115. COLA Part 2, FSAR Chapter 2, Figure 2.5.4-243 is revised as follows:

WILLIAM STATES LEE III
NUCLEAR STATION UNITS 1 & 2

Attachment 5
Revisions to FSAR Chapter 3

Cherokee Nuclear Station
Foundation Drainage and Lee Nuclear
Station Nuclear Island
FIGURE 2.5.4-244a

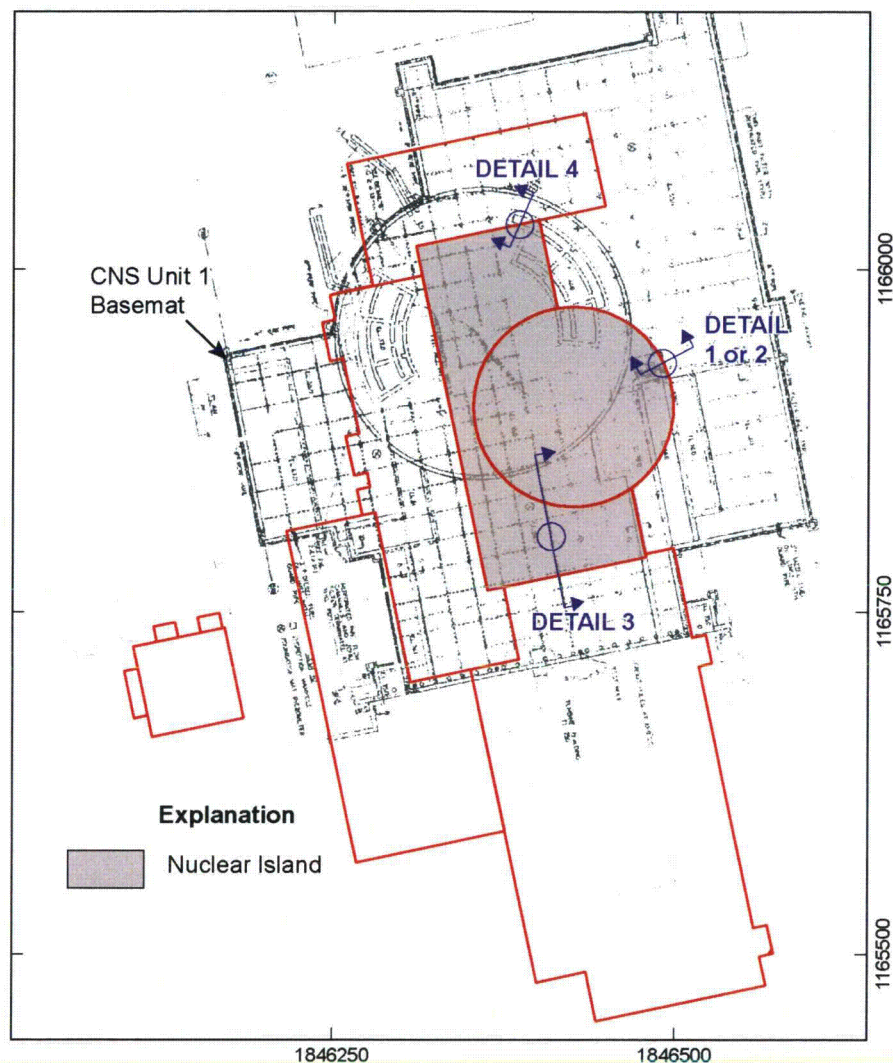
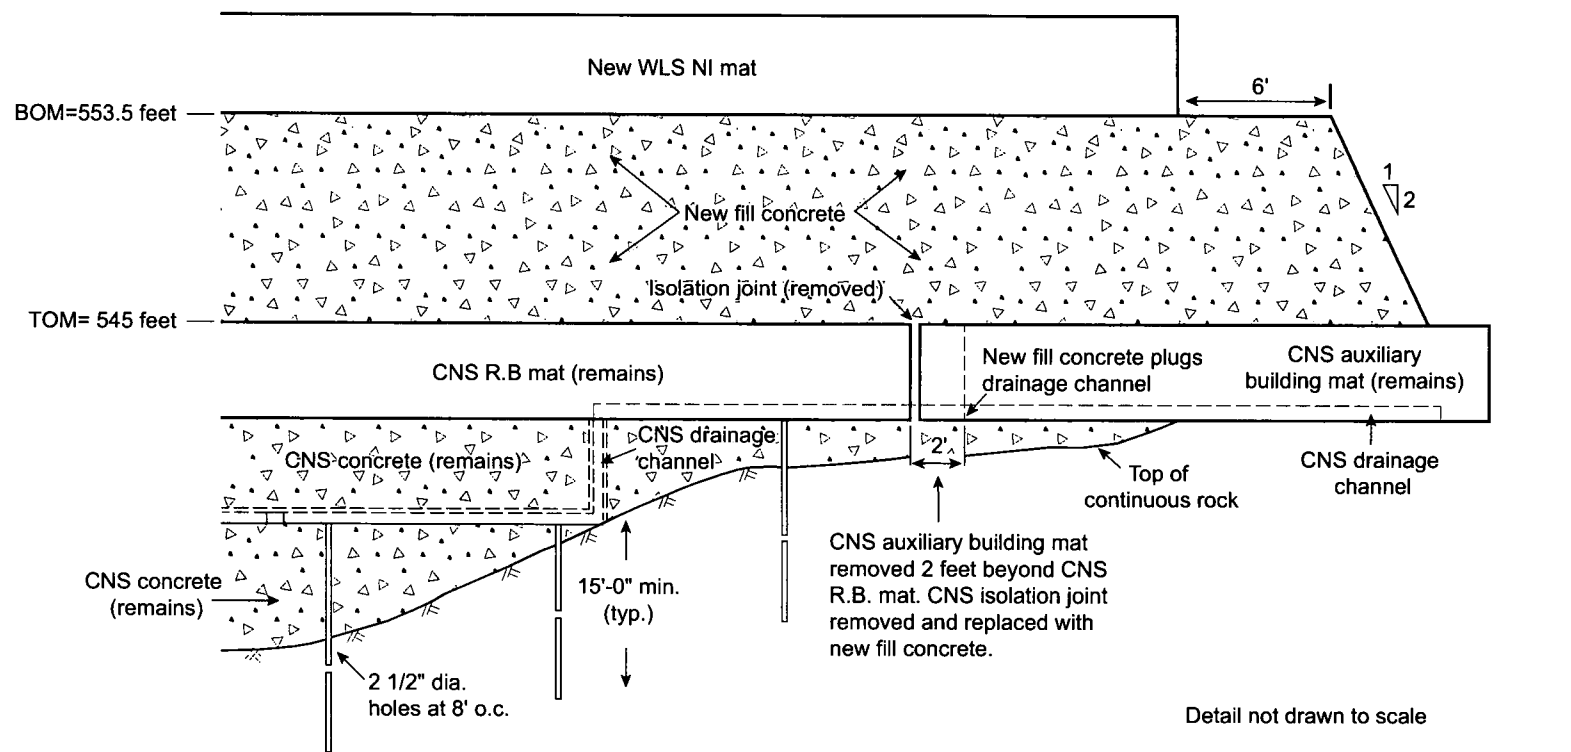
116. COLA Part 2, FSAR Chapter 2, Figure 2.5.4-244a is revised as follows:

1. PSAR Figure 2.4.13-1 "Typical detail for drain holes" and plan.
2. Relocated NI per Duke letter dated 10/17/2012, ML12293A238.

FIGURE 2.5.4-255a

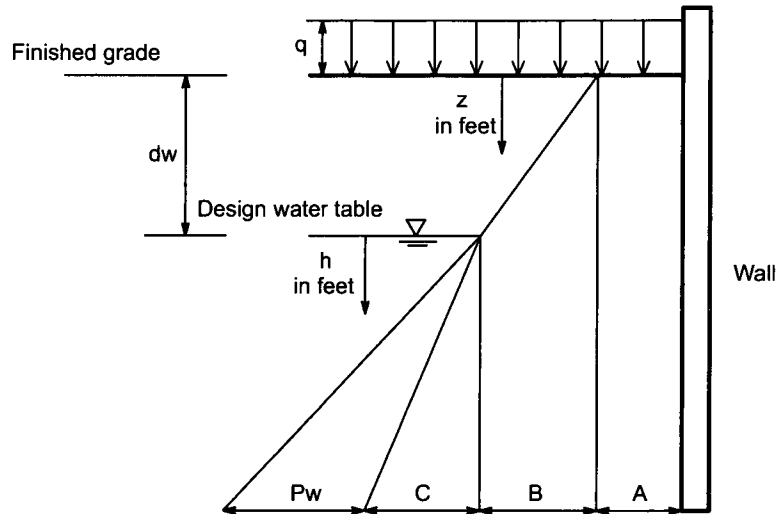
134. COLA Part 2, FSAR Chapter 2, Figure 2.5.4-255a is revised as follows:

FIGURE 2.5.4-256b

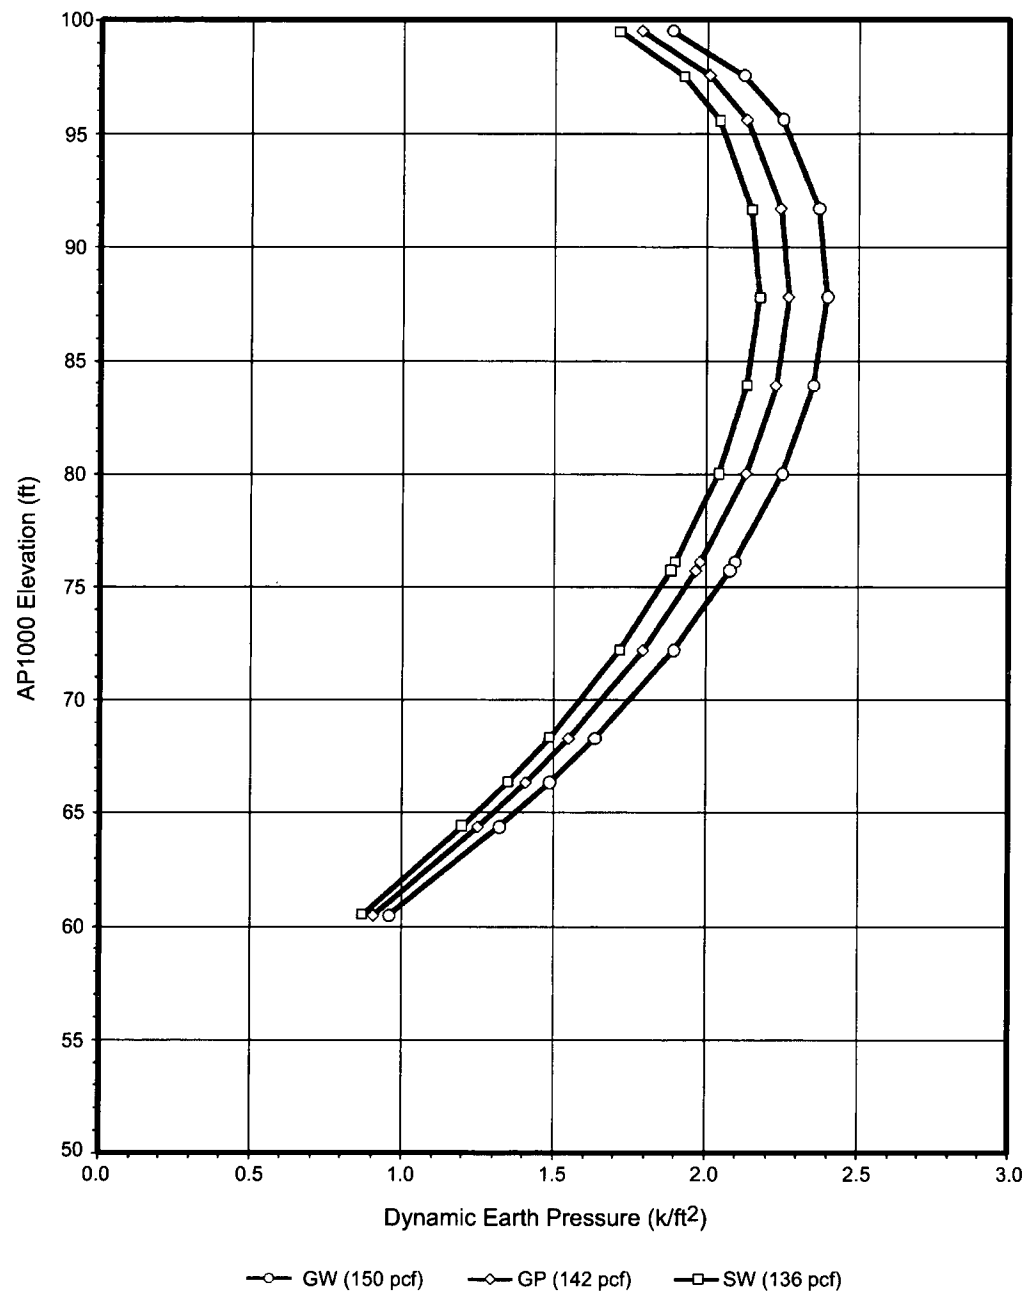
138. COLA Part 2, FSAR Chapter 2, Figure 2.5.4-256b is revised as follows:

FIGURE 2.5.4-266

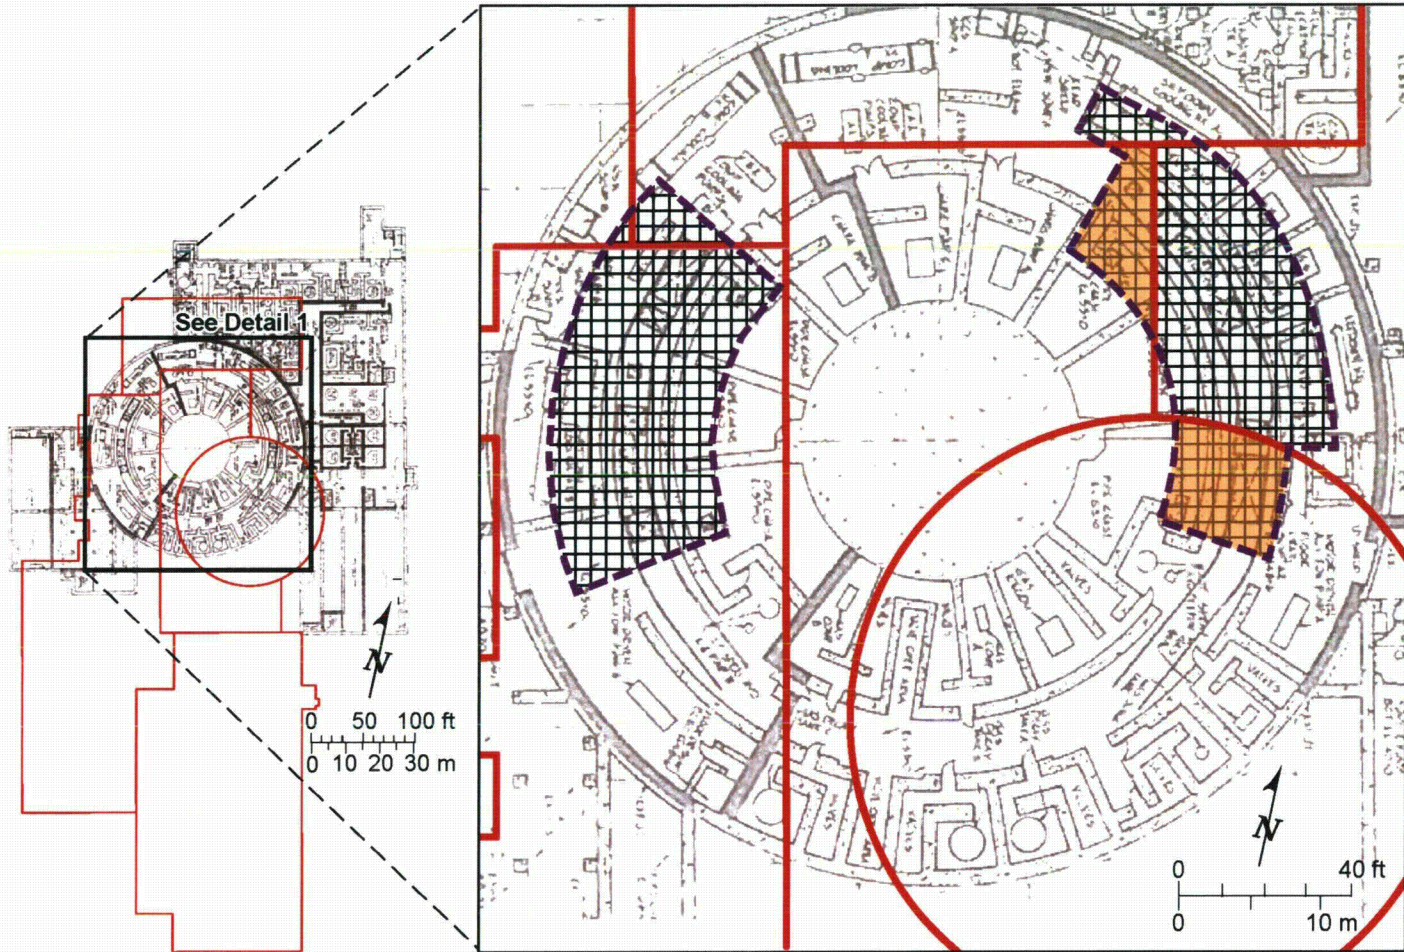
145. COLA Part 2, FSAR Chapter 2, Figure 2.5.4-266 is added as follows:

FIGURE 2.5.4-267

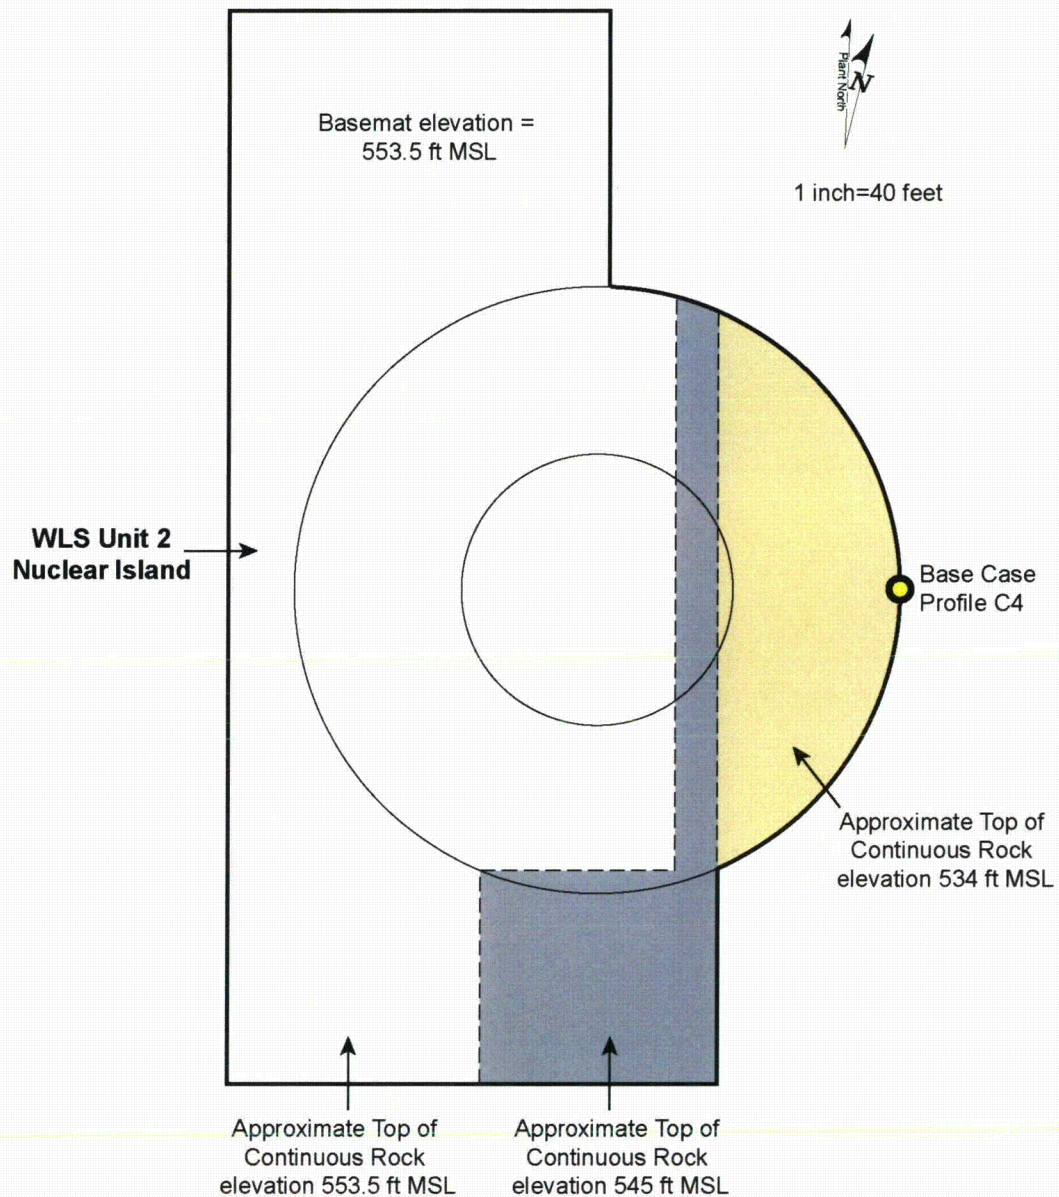
146. COLA Part 2, FSAR Chapter 2, Figure 2.5.4-267 is added as follows:

- Maximum WLS fill concrete thickness approximately 20 feet
- Maximum WLS fill concrete thickness approximately 9 feet
- WLS foundation level rock – no significant WLS fill concrete planned (less than 2 feet)

FIGURE 2.5.5-201

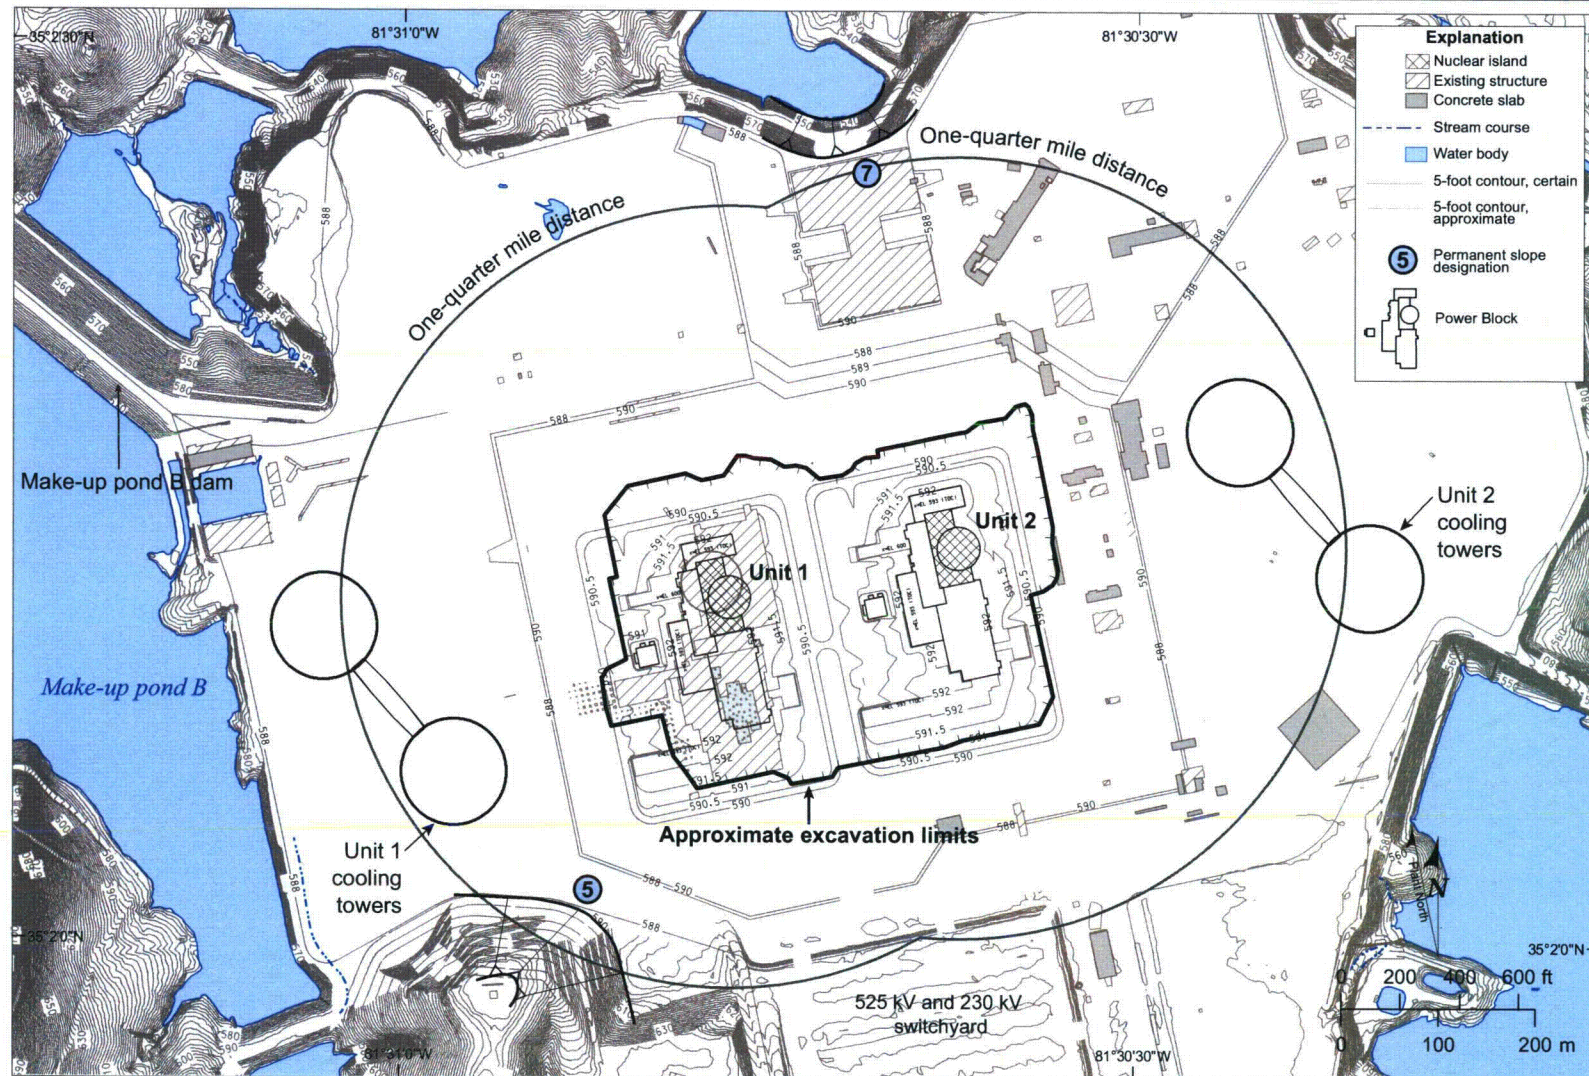
6. COLA Part 2, FSAR Chapter 2, Figure 2.5.5-201 is revised as follows:

FIGURE 3.7-202

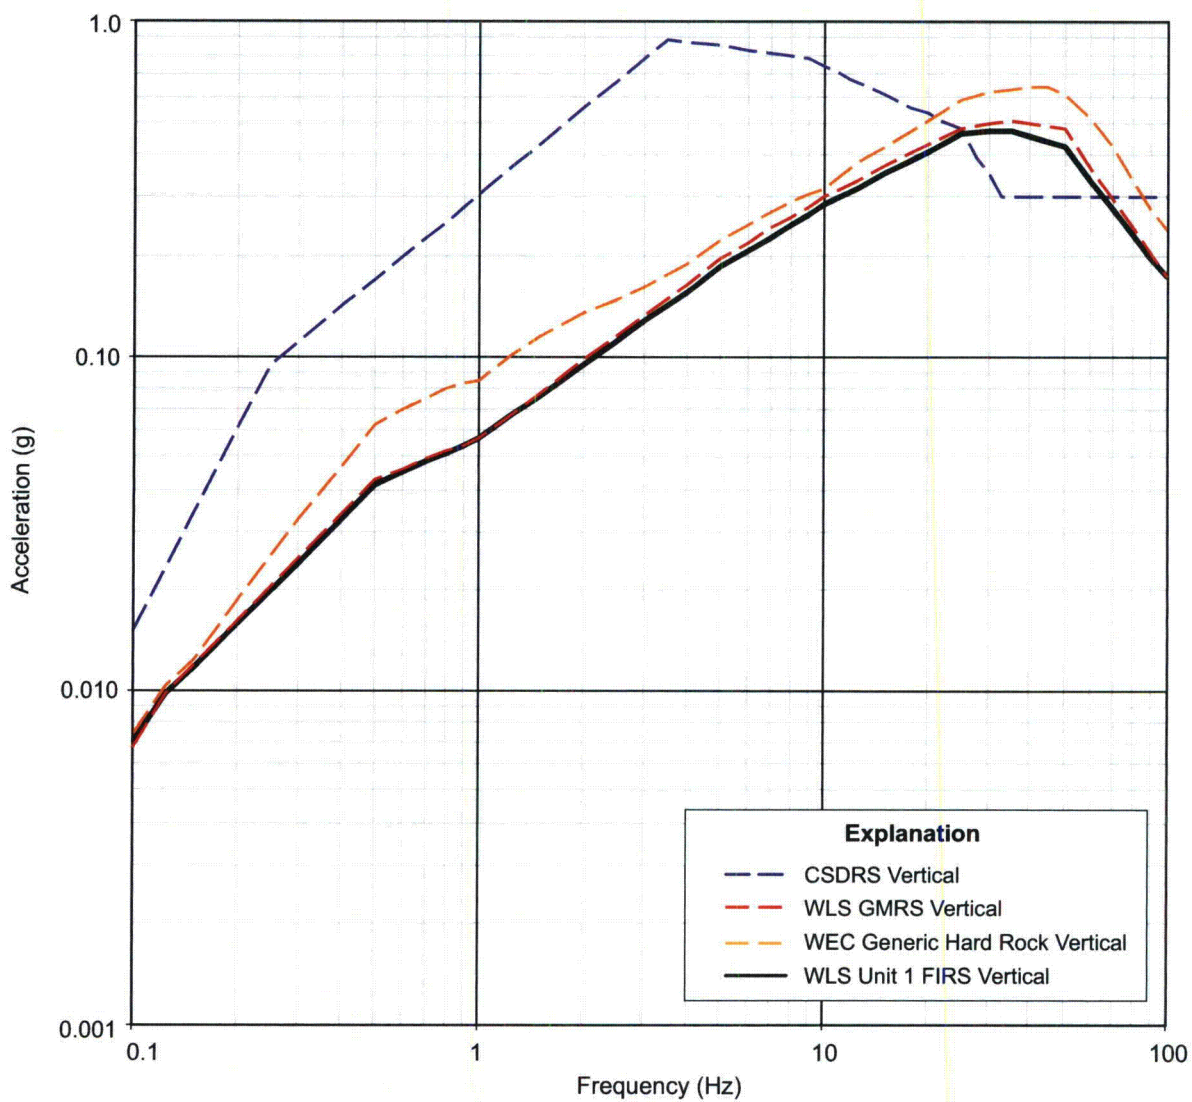
9. COLA Part 2, FSAR Chapter 3, Figure 3.7-202 is revised as follows:
